Re: Smith's Fuel Center #443
410 Yale Blvd SE
Request Permanent C.O. - Accepted
Engineer's Stamp dated: 8-19-11 (K16D024)
Certification dated: 9-1-11

Re: Smiths Fuel Center #443, 410 Yale Blvd SE
Utility Plan
Engineer's Stamp dated 8-19-11 (K16/D024)

Re: Smiths Fuel Center #443
Grading and Drainage Plan
Engineer's Stamp dated 3-15-11 (K16/D024)

RE: Smith's #443 Fuel Center, 410 Yale Blvd. (K16/D024)

SHEET NO.
C2.1

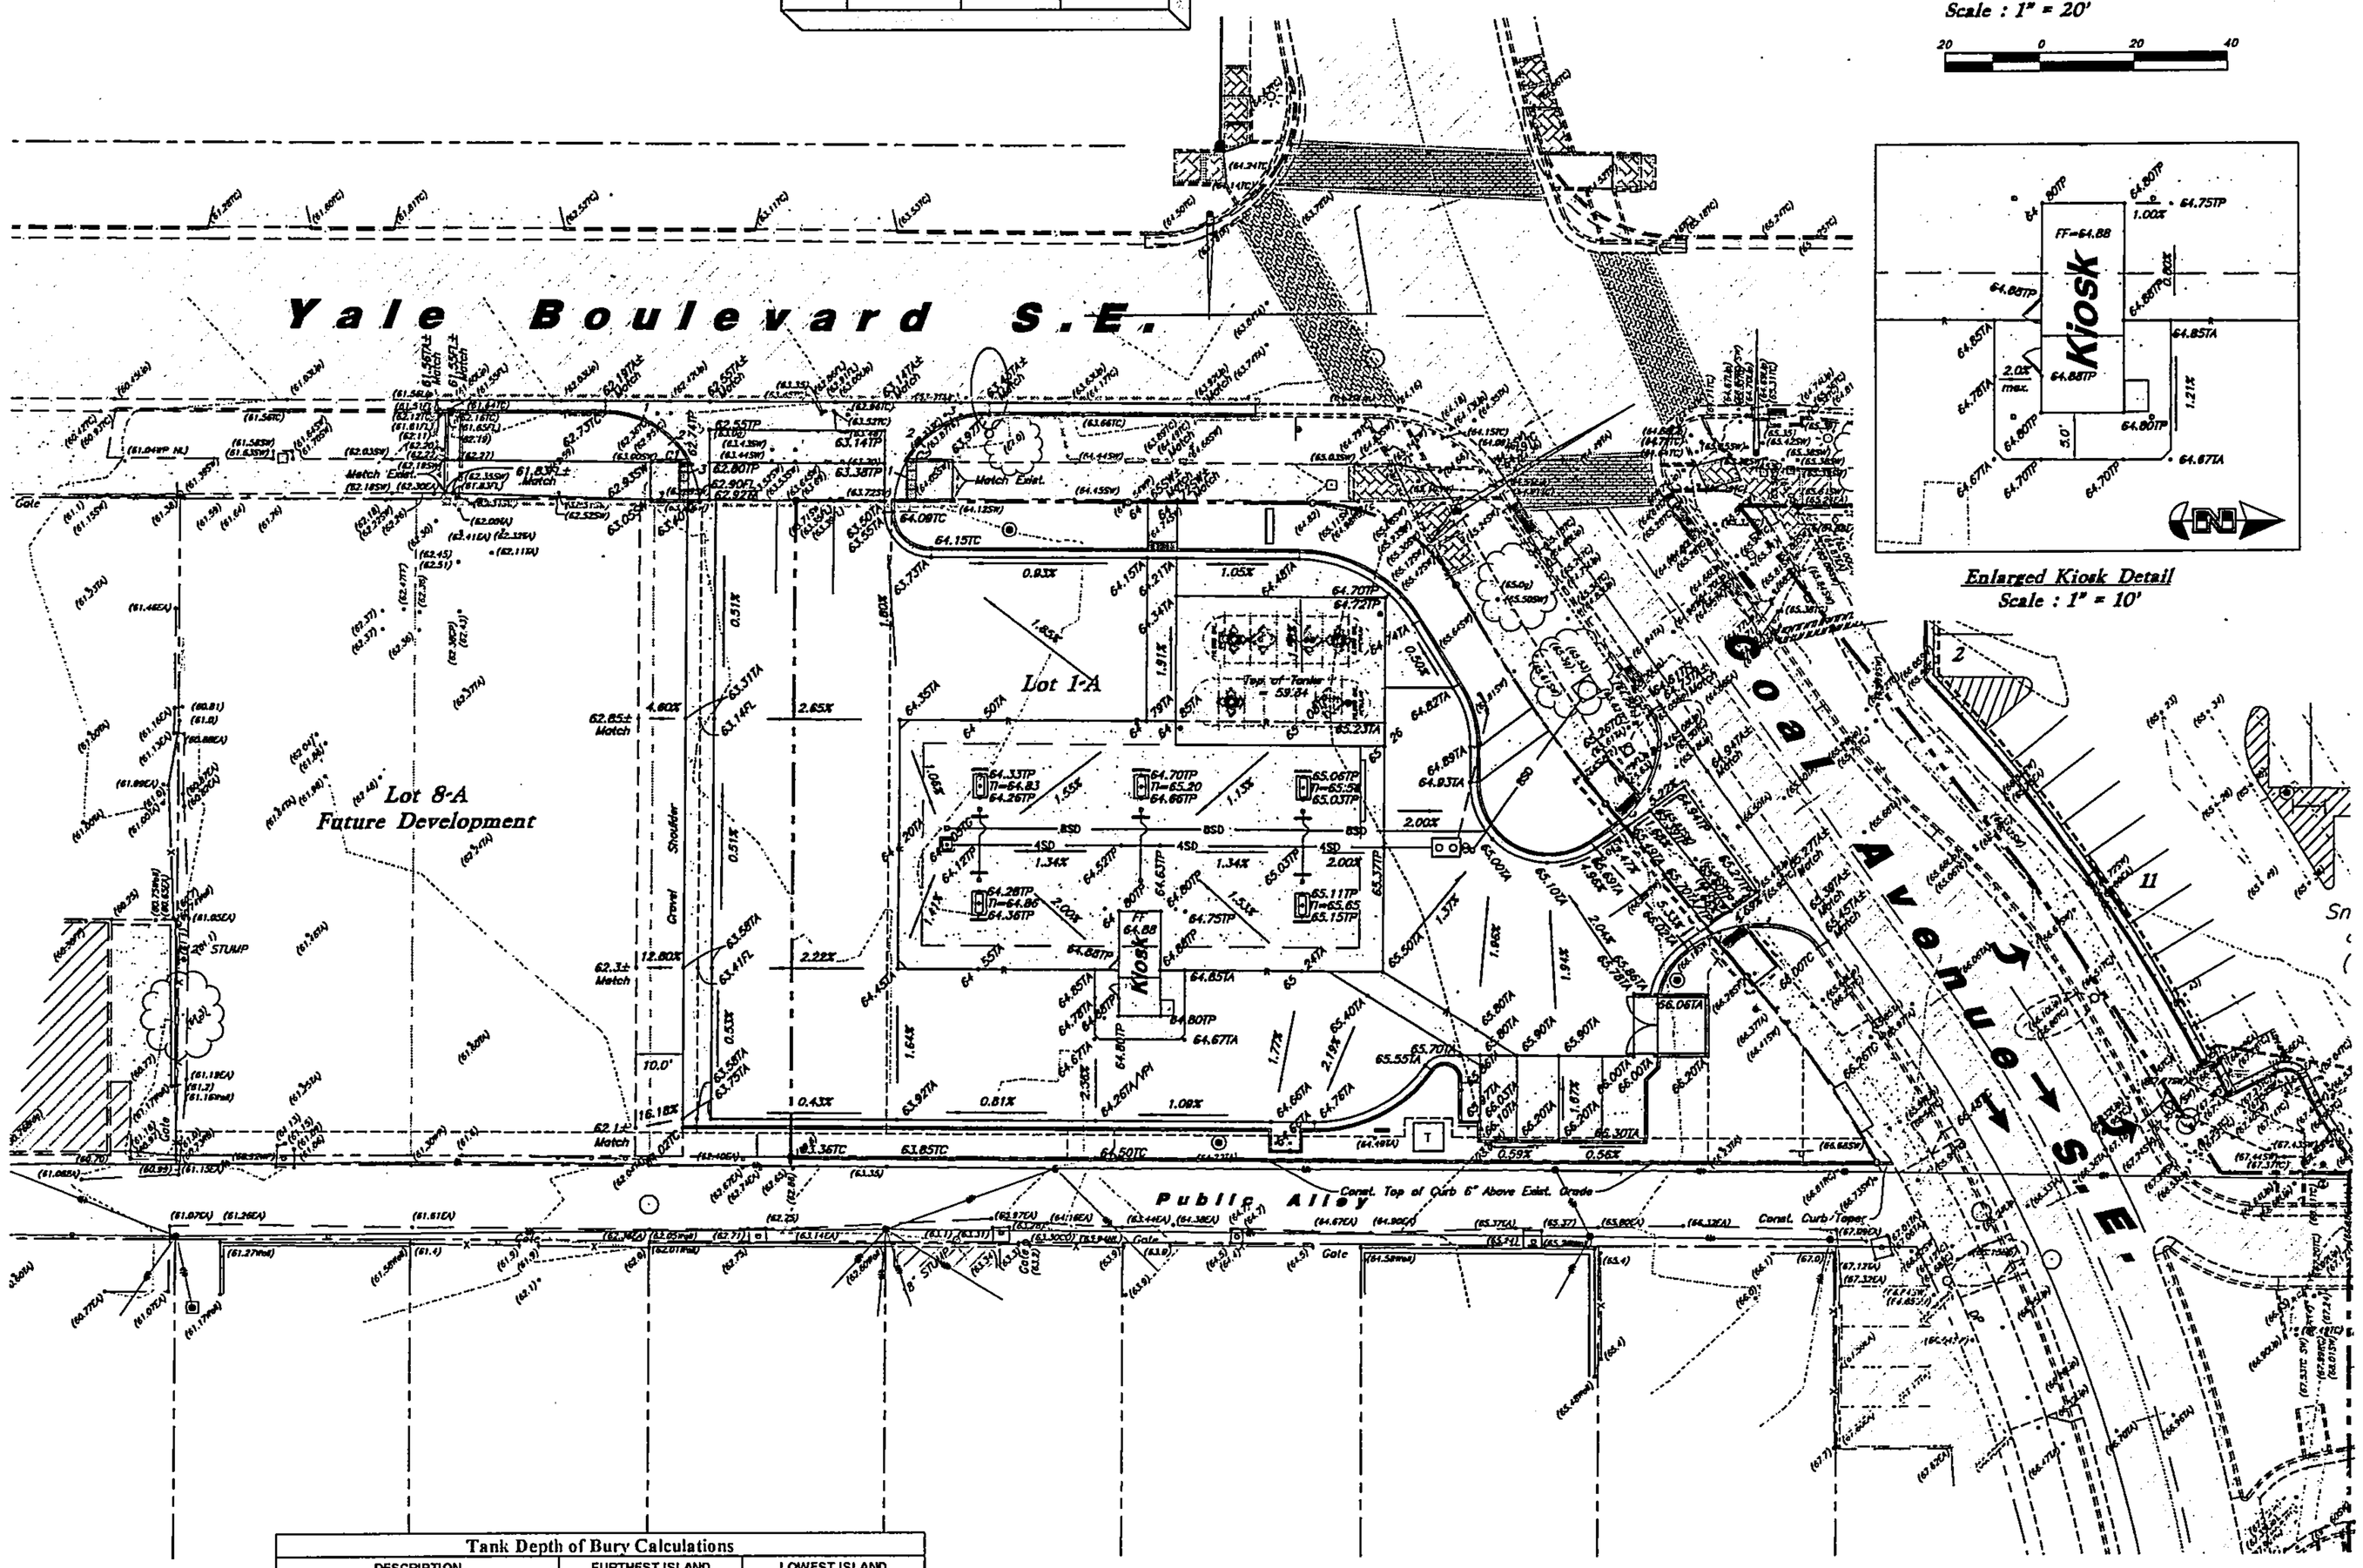
The contractor missed the grades considerably on the north end of the site according to your cert. It appears the north end of the lot is now draining under the canopy. I haven't determined if that's a problem or not yet. It is definitely not what you designed.

Hydrology is requesting that proposed landscape areas be depressed to retain/infiltrate the rain that falls on them.

We ran some water on it today and a small portion does get under the canopy. We will be fixing that so it doesn't.
Thanks
Kirk

SHEET NO.
C3.1

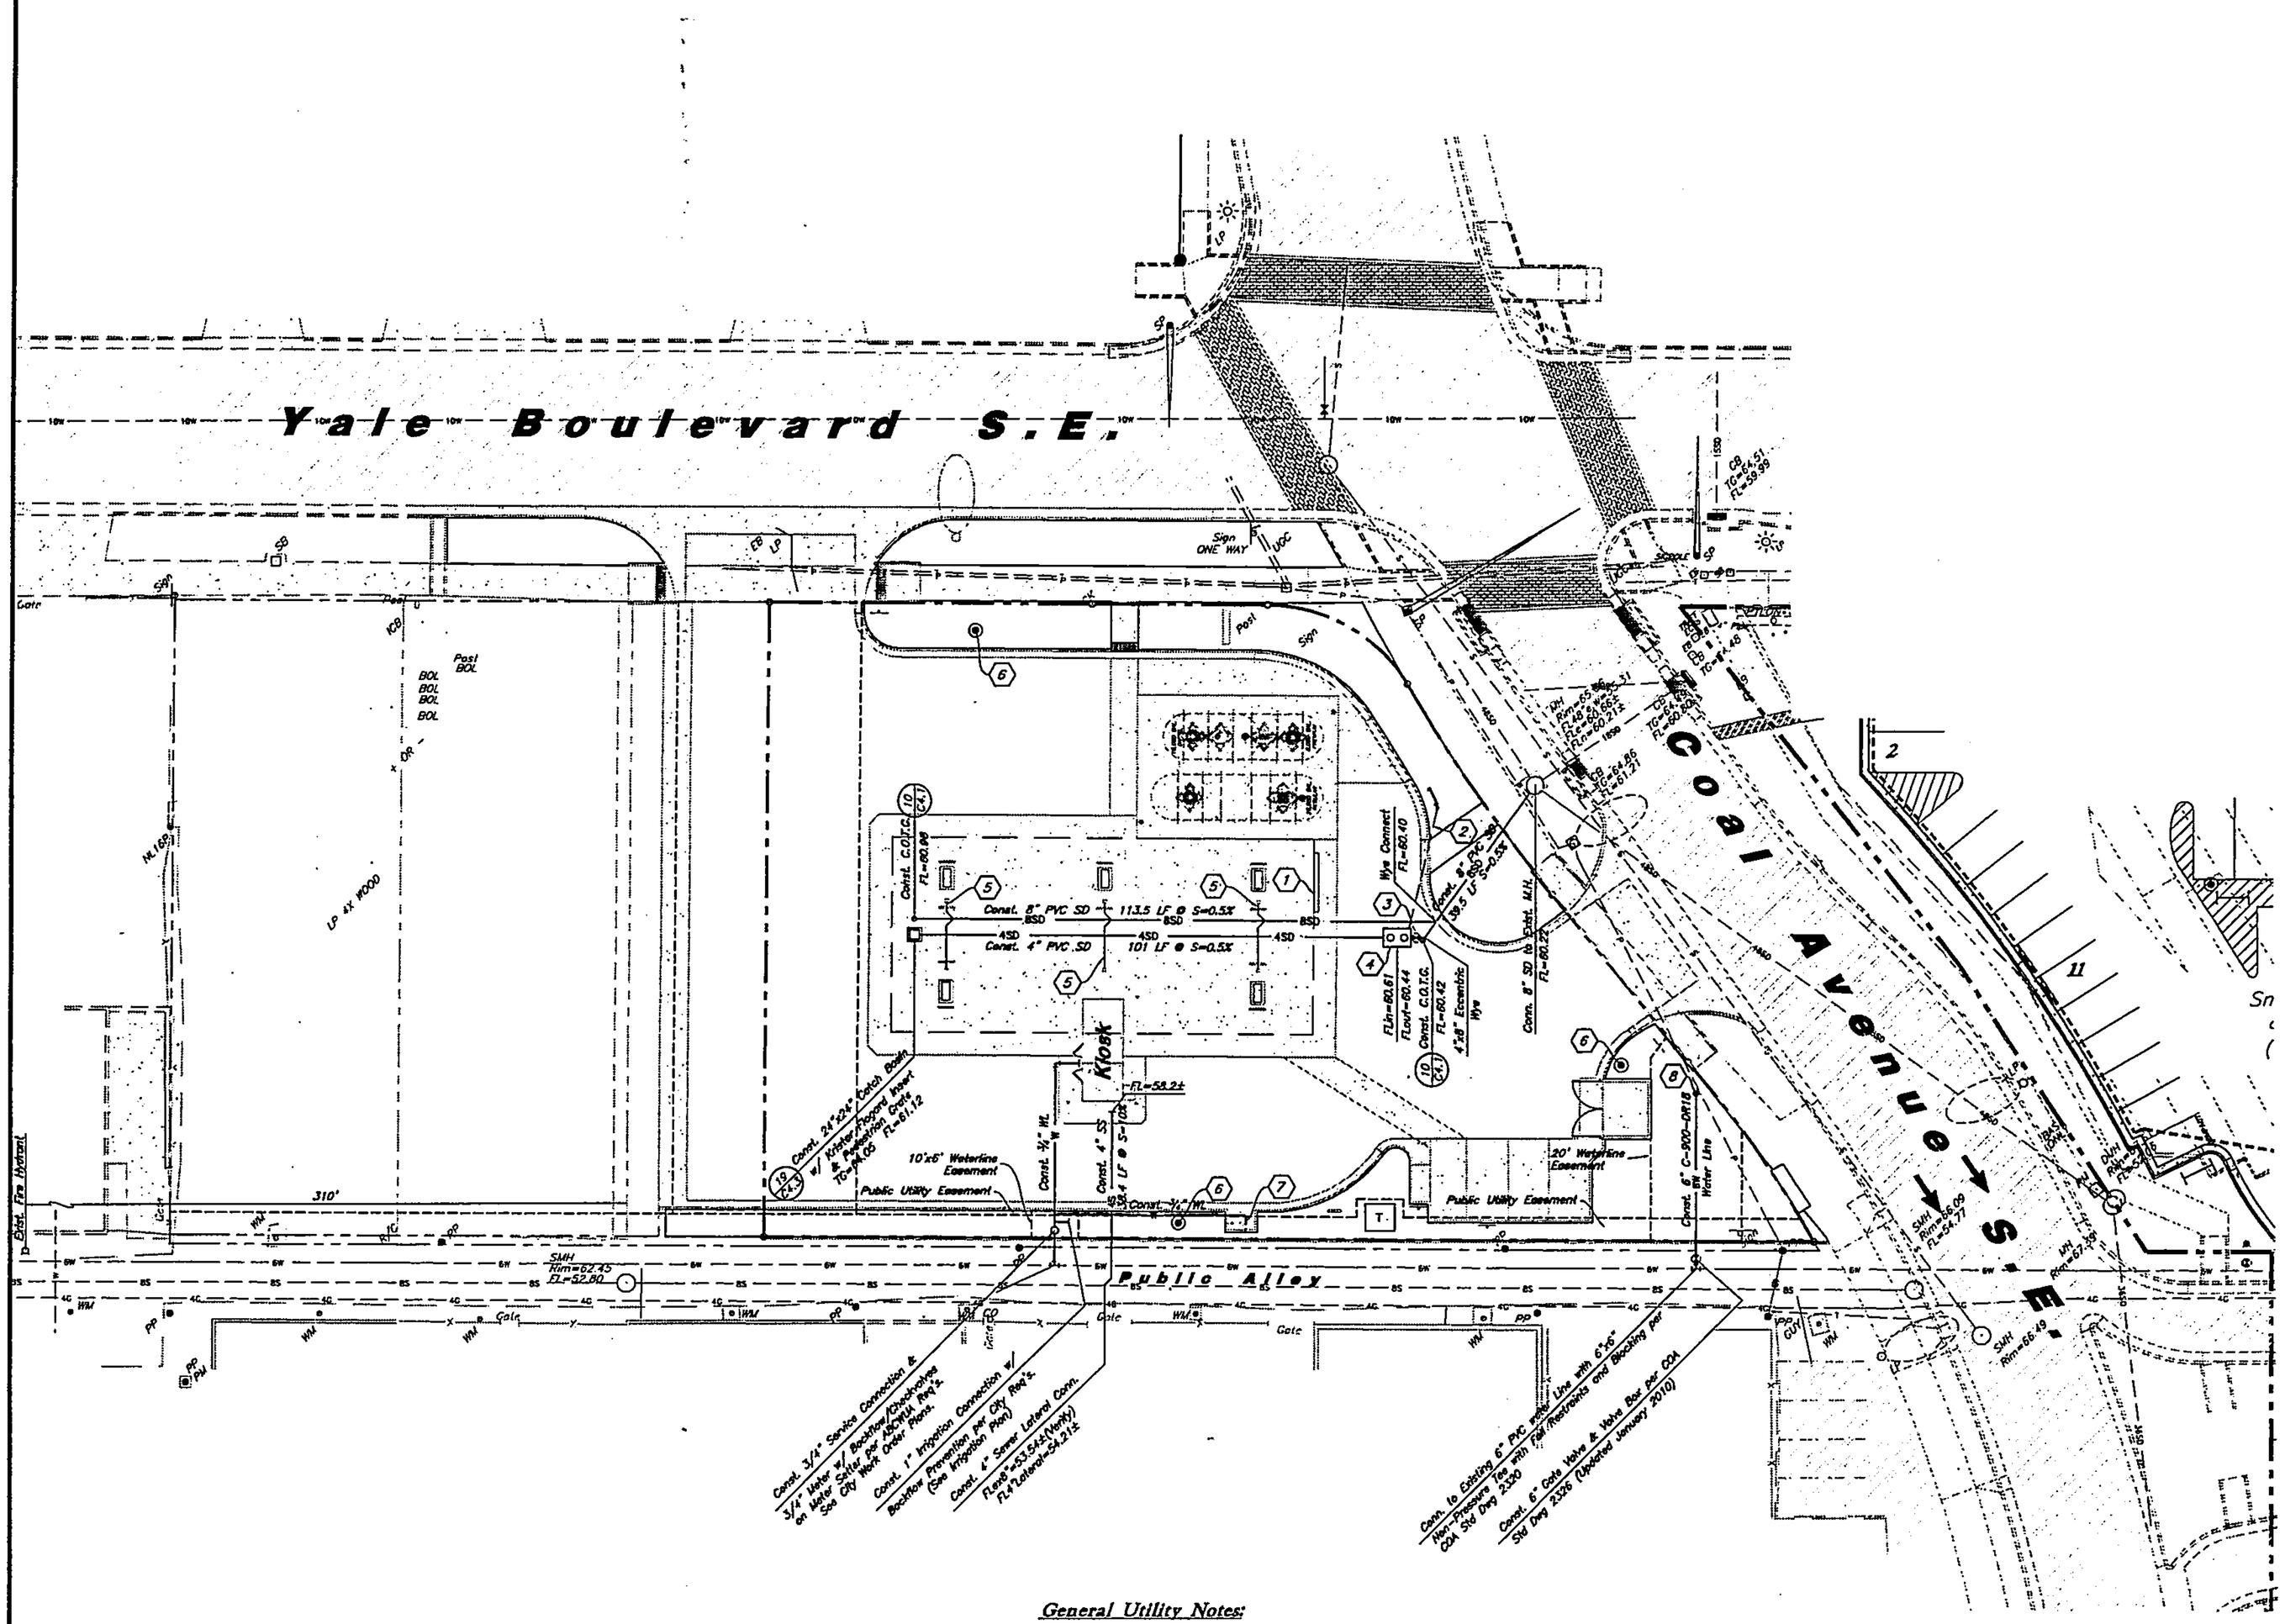
Kirk,
I approved the plan for the connection. The connection is required to be inspected and accepted prior to Temp or Perm CO. Martin Pacheco 235-8016.

Kirk,
You got the e-mail form Kathy.
I would like to know the invert(s) of the manhole.
So, I need an updated G & D, with a build note similar to " Connect to existing storm drain manhole per COA STD DWG 2118. SO 19 Permit required.
And another build note telling the contractor to bore it (rather than trench).
Add the SO 19 notes (attached) to sheet C3.1.

Attached is a copy of the Utility Plan which should clarify questions about inverts, pipe sizes and storm drain connections.

See attached utility plan, this ties into the existing storm drain.
